1964 Corvette: Engineering Service Letter: Muncie Four Speed Transmission Design Change

ENGINEERING SERVICE LETTER

SUBJECT: MUNCIE FOUR SPEED TRANSMISSION - 1964 DESIGN
CHANGE AFFECTING PAST MODELS SERVICE REPLACEMENT
AND A FIELD FIX IF REQUIRED

DATE 8-20-63
SECTION 7
MODEL RPO M20 800-
1200-1600-1800 & RPO
M21-1200-1600-1800-1963

For a comparison between the new and old design in the transmission area affected see attached sketch. Old parts indicated by an asterisk (*) are no longer required as part of revised design.

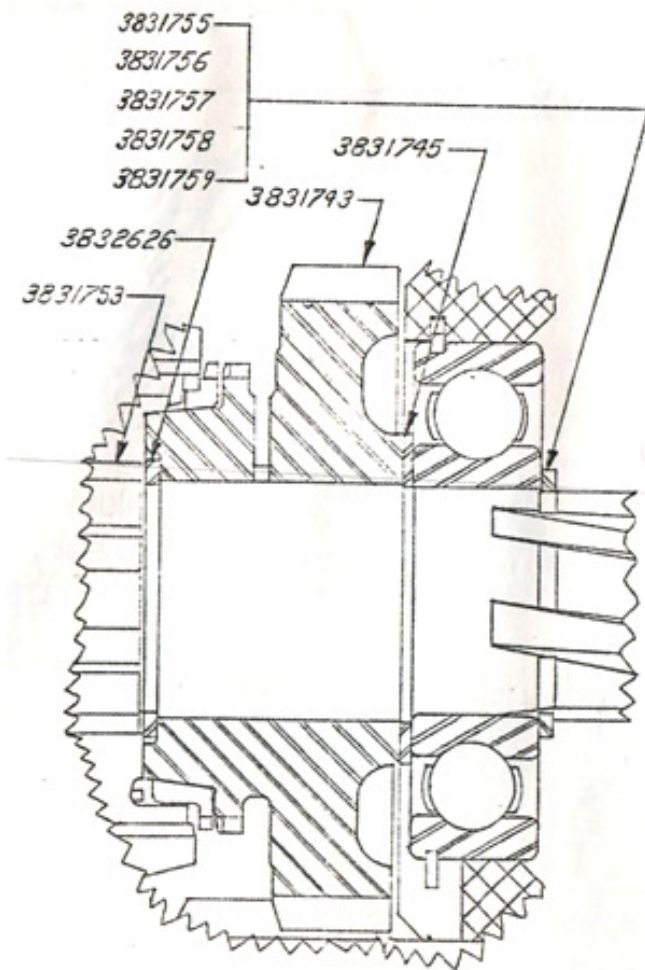
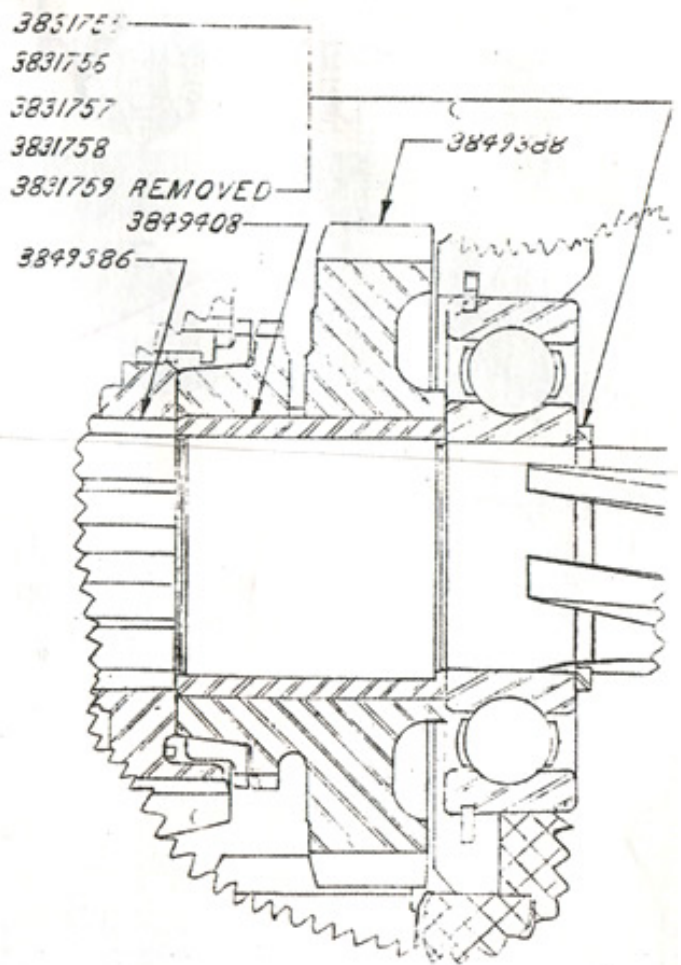
A design change is being introduced for start of production 1964 on subject transmission which includes a new transmission mainshaft, first speed gear, and first speed gear sleeve. The new parts are not interchangeable as details for service replacement on past models. The reasons for the changes are to provide positive first speed gear end clearance, and also to eliminate the possibility of seizure between the inside diameter of the first speed gear and the matching mainshaft outside diameter by use of a new sleeve. The seizure has been reported from the field in several instances at relatively low mileage, and the new parts indicated above are to be used for past model service replacement if this type of transmission failure is noted.

The following is a list of the new parts and past model parts affected by this design change:

<u>New Parts</u>	<u>Old Parts</u>	<u>Name</u>	<u>Production Disposition</u>
3849386	3831753	Shaft - Trans. Main	Cancelled & Repl. by 3849386
3849388	3831743	Gear - First Speed	Cancelled & Repl. by 3849388
3849408	-----	Sleeve - First Speed Gear	New
-----	*3831745	Washer - 1st Speed Gear Thrust	Cancelled & Not Replaced
-----	*3831759	Ring - Trans. Main Shaft Rear Brg. Retainer	Cancelled & Not Replaced
-----	*3832626	Ring - Trans. 1st & 2nd Synchronizer Retaining	Cancelled & Not Replaced

Approximately 20,000 total Muncie Transmissions of the first design will be built before this change is introduced.

From the viewpoint of excessive cost to the customer, if the combination of new parts was used for all past model service replacement, it was decided to maintain old stock.
